Technical Specification Change

TS 3.17 Limiting Linear Heat Generation Rate

TS 3.18 Power Distribution Monitoring and Control  
(Power vs. Offset Envelopes)

# TECHNICAL SPECIFICATION FIGURE 3.18-1b POWER VS OFFSET, 100 - 200 EFPD

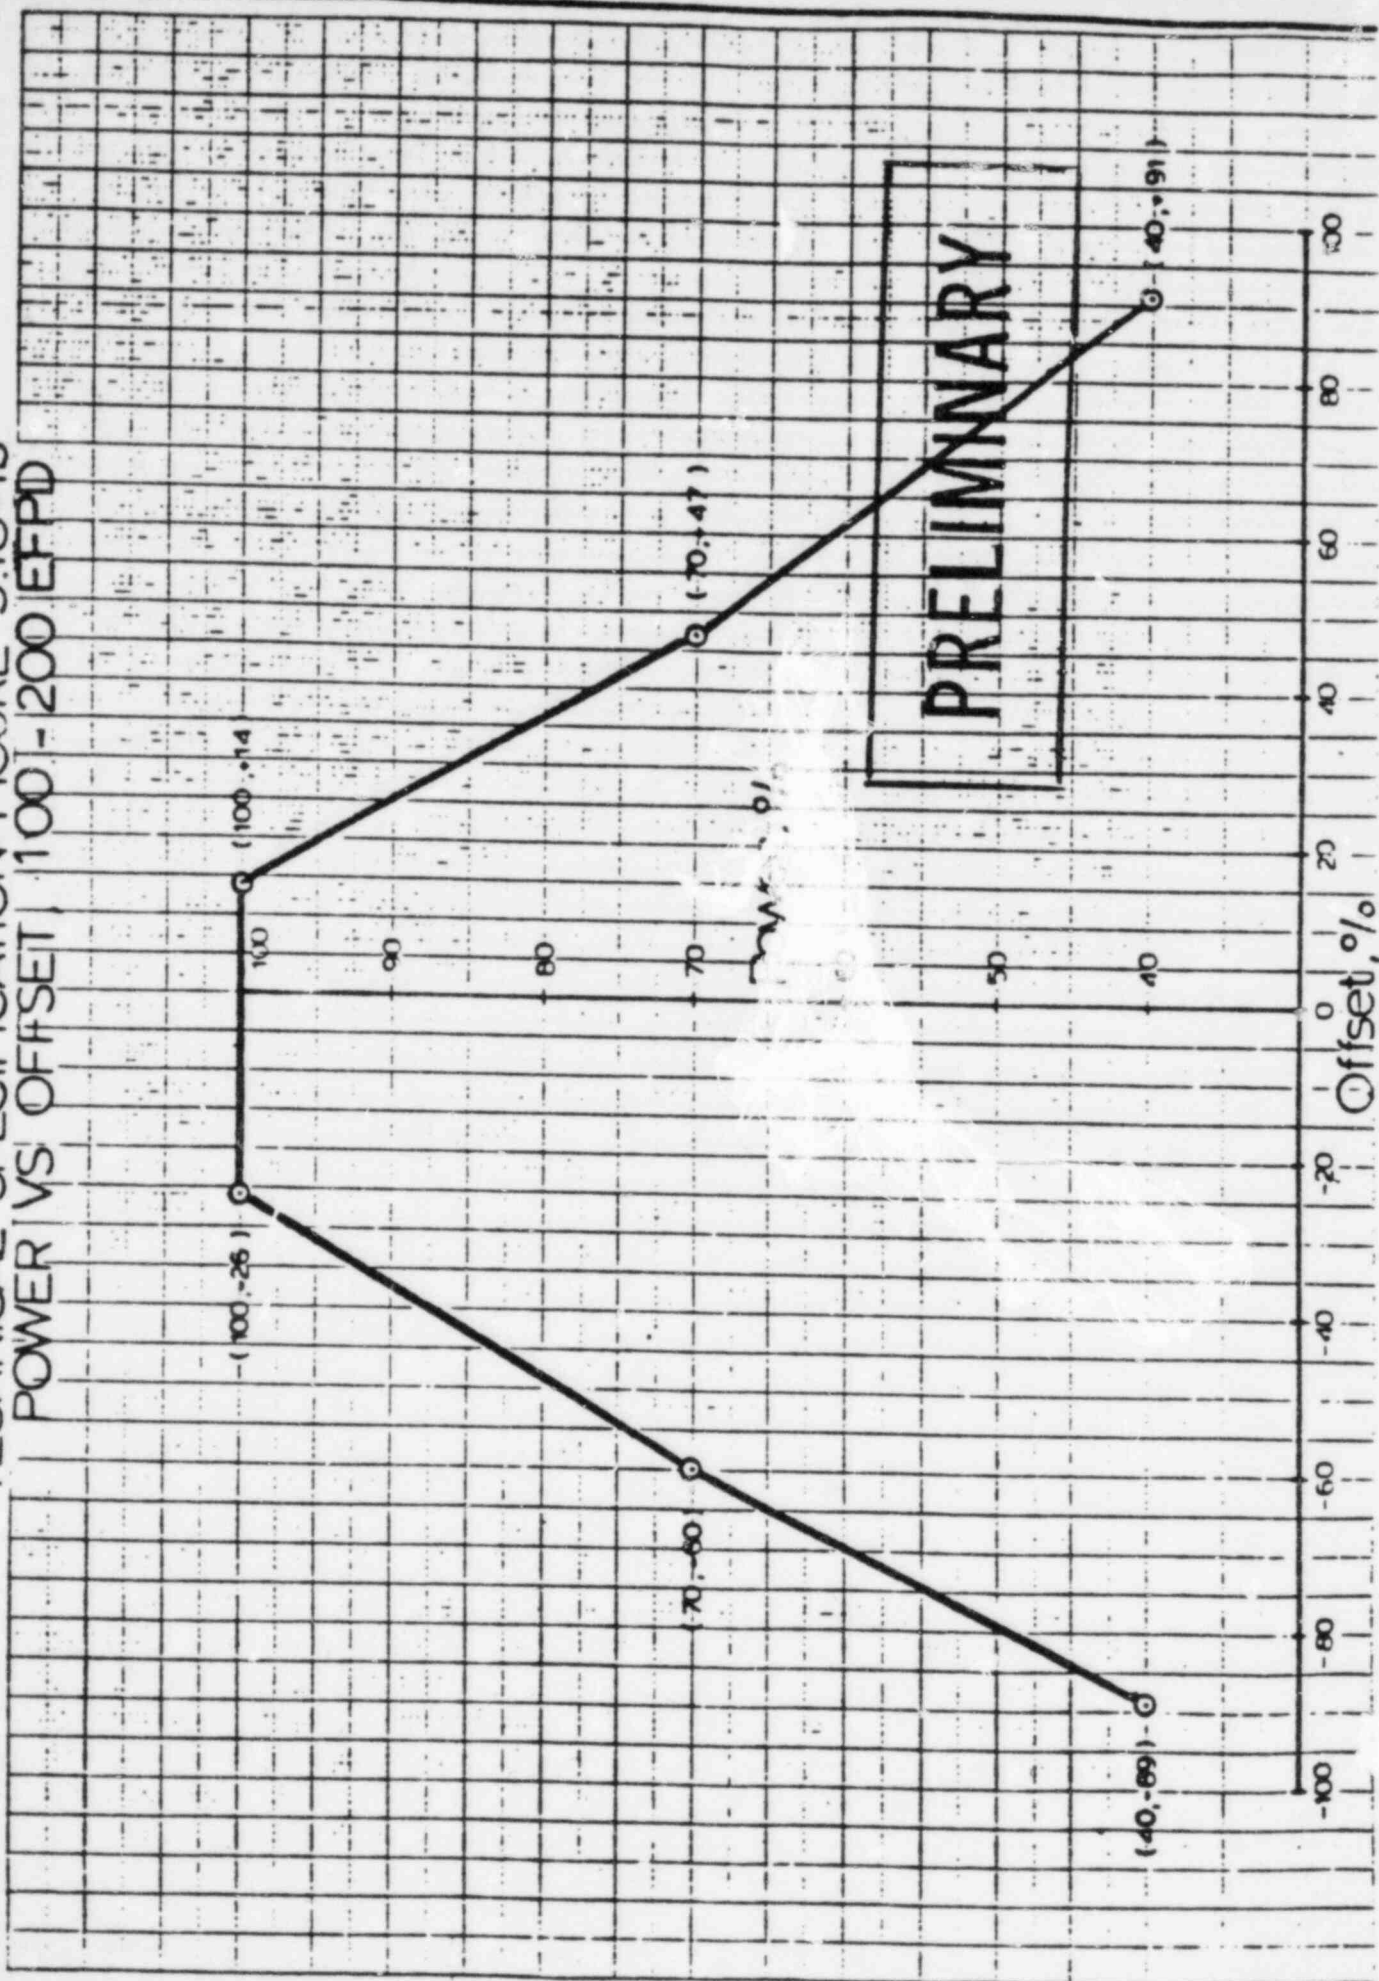
- B.1.1.a Provides continuous monitoring of the incore power distribution by means of the out-of-core power range detectors. Operation within the axial offset envelope of Figure 3.18-1 assures that the local heat flux will not exceed the peak linear heat rate limits defined in Specification 3.17. Specific axial offset versus power curves for future reloads will be calculated and checked against Figure 3.18-1 to insure continued applicability.
